UNITED STATES
NUCLEAR REGULATORY COMMISSION
WASHINGTON, D.C. 20555-0001

SUBJECT: SUMMARY OF THE NOVEMBER 10, 1999, MEETING BETWEEN THE
NUCLEAR REGULATORY COMMISSION STAFF AND PACIFIC GAS
AND ELECTRIC COMPANY (TAC NO. L23001)

Docket Nos.: 72-26 (50-275, -323)
72-27 (50-133)

Humboldt Bay and Diablo Canyon ISFSIs

Humboldt Bay ISFSI Controlled Area

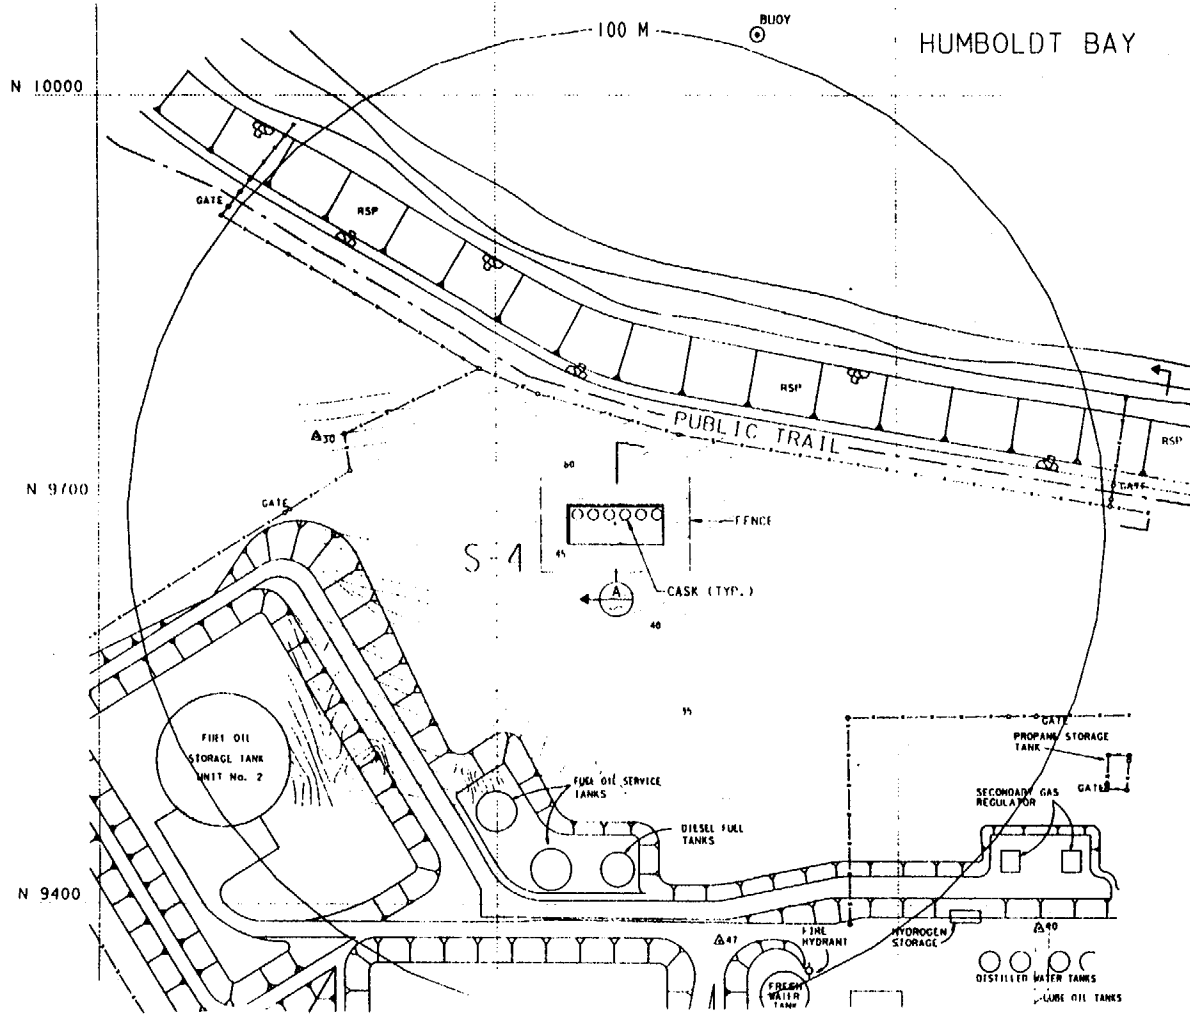
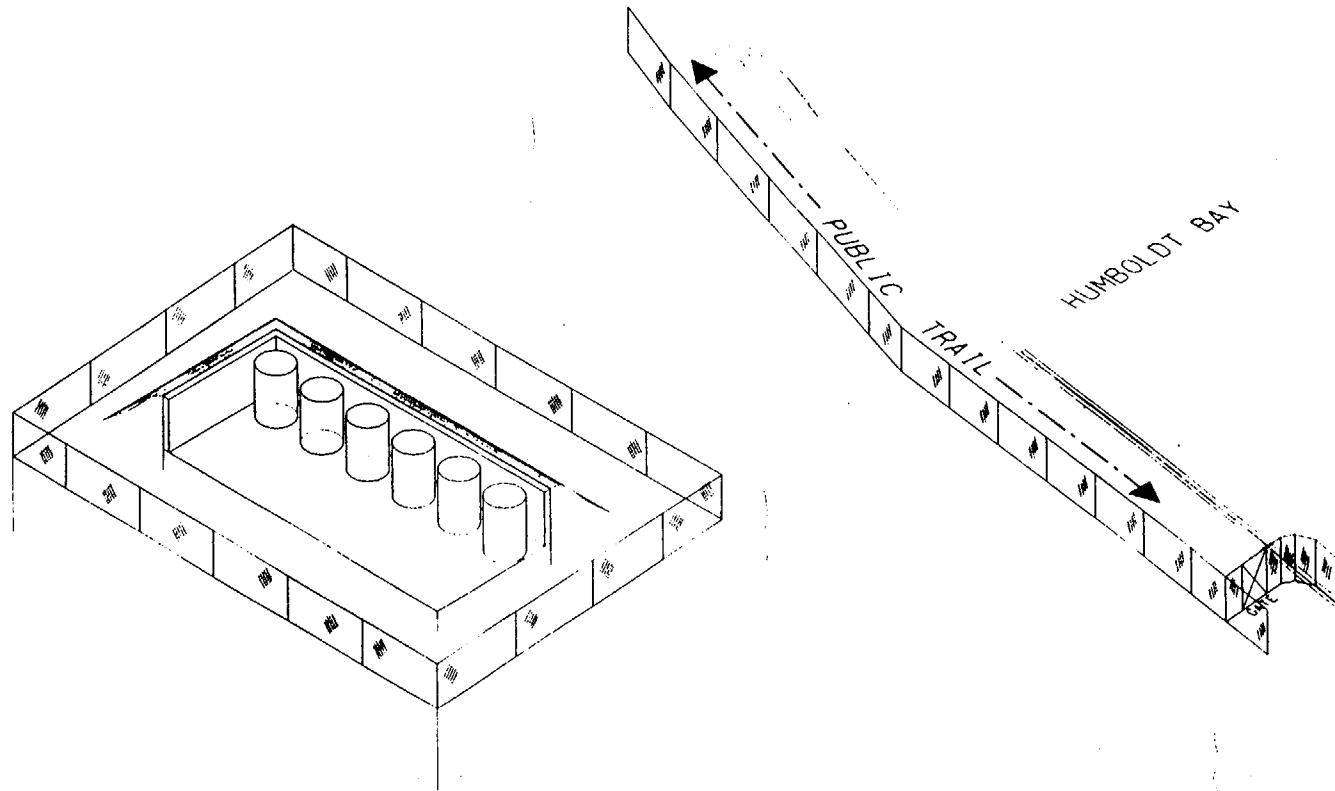
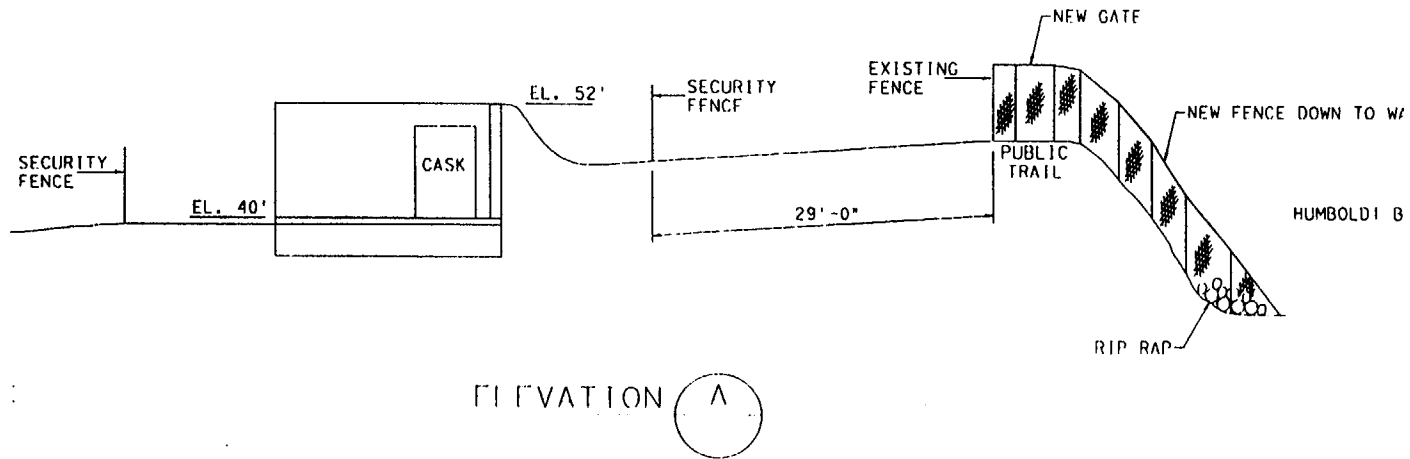
PG&E described the site for the Humboldt Bay ISFSI and discussed the basis for its selection. The site's proximity to a public trail was noted; the trail falls within the 100 meter controlled area boundary specified in 10 CFR 72.106(b). PG&E indicated that they will propose to take necessary actions to control access to that trail and protect public health and safety, in accordance with the provisions of 10 CFR 72.106(c). The NRC staff indicated that further discussion is warranted regarding the need for an exemption, and that safeguards implications should also be considered.

- The controlled area boundary is 100 meters from the nearest spent fuel storage cask (in accordance with 10 CFR 72.106)
- PG&E owns all property within the 100 meter controlled area
- PG&E will establish measures to control activities, when necessary, for those parts of the public trail, bayside rip rap, and bay that are within the 100 meter distance
